VOGTLE OLSE
INSERTION INSTRUCTIONS
AMENDMENT 2, APRIL 15, 1984

VEGP-OLSER-2

NUCLEAR REGULATORY COMMISSION
QUESTIONS AND RESPONSES INDEX
VOGTLE ELECTRIC GENERATING PLANT - UNITS 1 AND 2
OPERATING LICENSE STAGE ENVIRONMENTAL REPORT
NRC DOCKET NUMBERS 50-424 AND 50-425

FIGURE 3.9-2

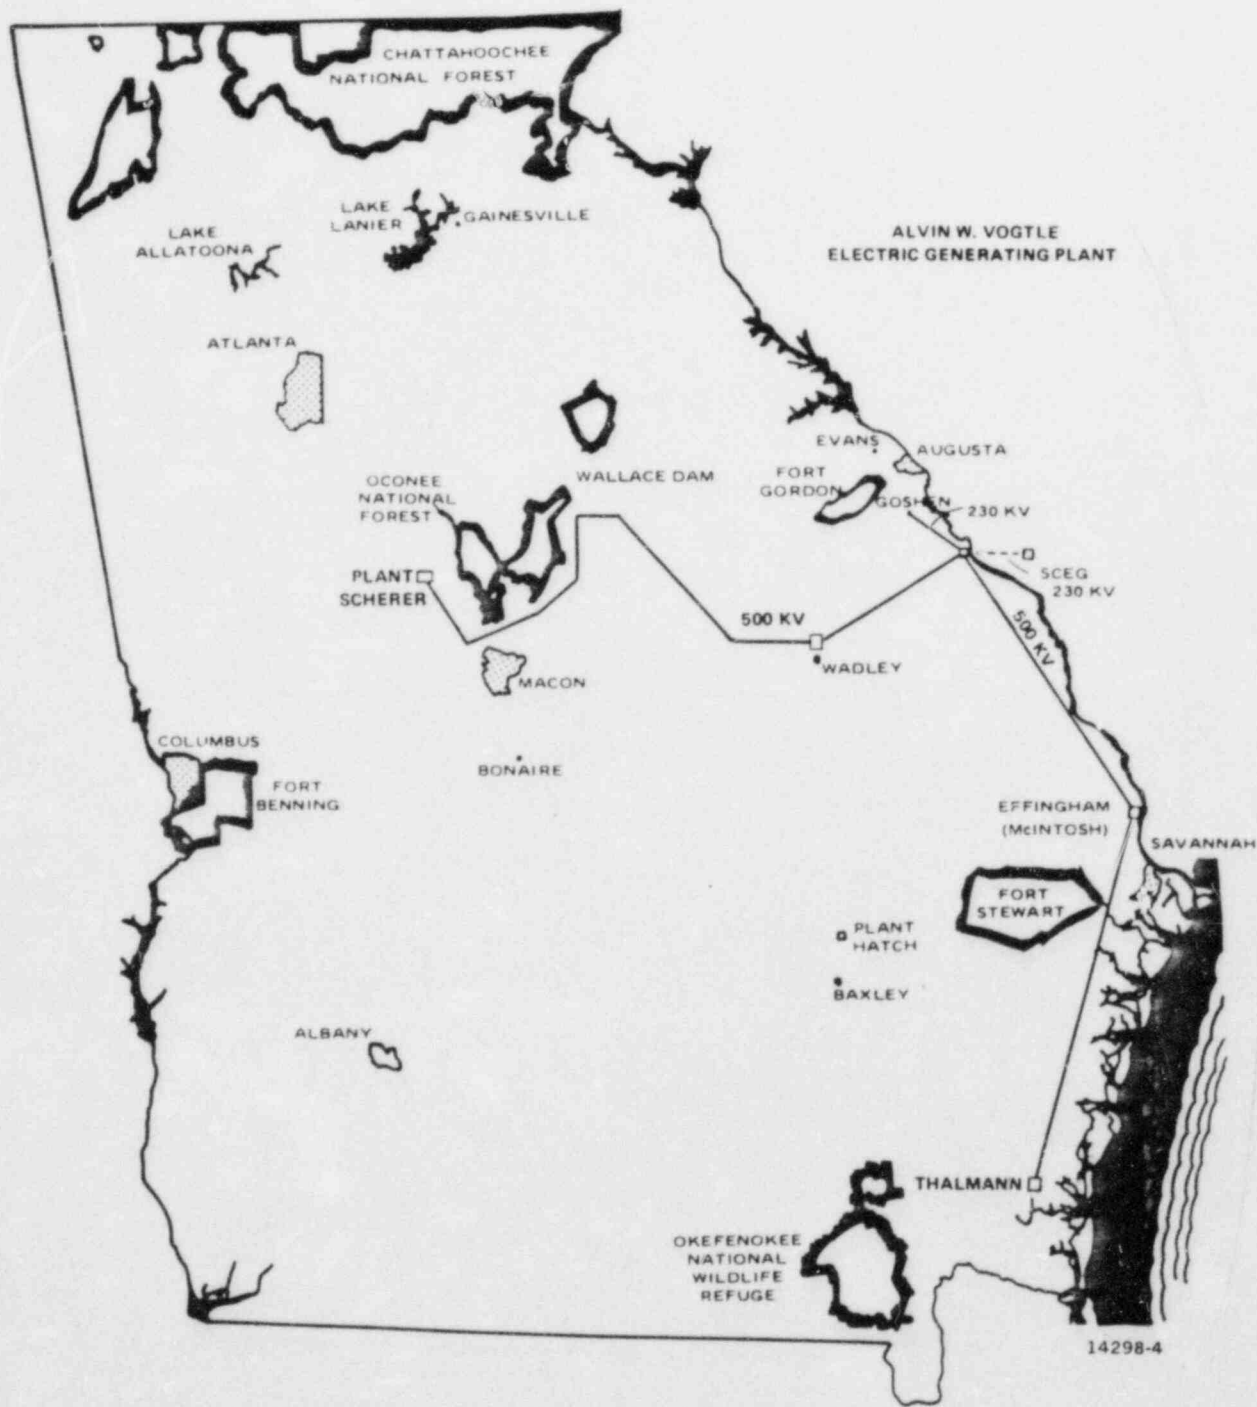
This section states that changes to the transmission line rights-of-way since the Construction Permit (CP) were provided to the Nuclear Regulatory Commission (NRC) by letter dated February 1, 1982, from D. Dutton, Georgia Power Company (GPC), to D. Eisenhut, NRC. The maps included with this letter show a completely new 500-kV line going from the Vogtle plant to the Effingham plant.

Attachment 2 of the February 1, 1982 letter labels the Vogtle to North Goshen line as 230 kV. Does this mean that the two 500-kV lines proposed at the CP stage (Final Environmental Statement-Construction Permit (FES-CP), page 3-40) between these two points

Attachment 2 also shows a line going from the Vogtle plant to Wadley with a short spur to Waynesboro. Provide details of any modifications of this line since the CP stage.

Figure 3.9-2 indicates the currently proposed transmission system. This system is based on current planning studies evaluating substation and interconnection needs for the Georgia integrated transmission network. Changes from the CPSER are due to a reduction from a four-unit plant to a two-unit plant as well as changes to construction schedules of substations and lines. The system described in figure 3.9-2 supersedes past system descriptions in the CPSER and intervening changes such as those described in D. E. Dutton's letter to D. G. Eisenhower of February 1, 1982.

Section 3.9 of the VEGP-OLSER has been amended to provide a description of the current planned transmission system associated with VEGP Units 1 and 2. The following addresses responses to the specific items requested in question 290.4.

- G. Specific tower locations have not been identified for much of the proposed transmission system. Tower locations for the VEGP-Wadley portion of the transmission system were reviewed by the staff during

the March 21-22, 1984 site visit. Substation locations, existing and possible future additions, are illustrated on figure 3.9-2 of the VEGP-OLSER.
